**08\_0167 MOD2, Modification to Residential Subdivision - 08\_0167 MOD 2**

**RE: Section 75W Modification of Consent – Stage 10 and 11 of MP 08\_0167  
Lot 36 DP 1214499 Belle O'Connor Street, South West Rocks.**

The purpose of this letter is to address matters raised in agency and public submissions to the proposed modification of consent.

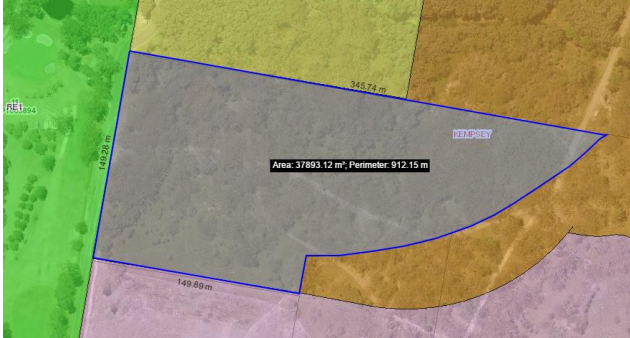
***Vehicular access – The documentation does not demonstrate how vehicular access to Lot 36 will be provided if it is to be developed independently of Stages 1-9 of the project. It would seem that the development of Lot 36 will be reliant upon Stage 1A being completed first, in particular the extension of Burrawong Drive from the Belle O'Connor roundabout. Alternatively, a portion of the extension of Burrawong Drive could be constructed in***

Development of Lot 36 under the proposed modification is not reliant on any other stages of the project approval.

It is proposed to construct the extension of Burrawong Drive from the existing roundabout to Road No.1.

The timing of the construction of that section of Burrawong Drive will depend on which Stage of the project approval commences first. In this regard, it is understood that Council has prepared a draft S94 plan for road connections in the Saltwater area including the cost to construct the Burrawong Drive extension.
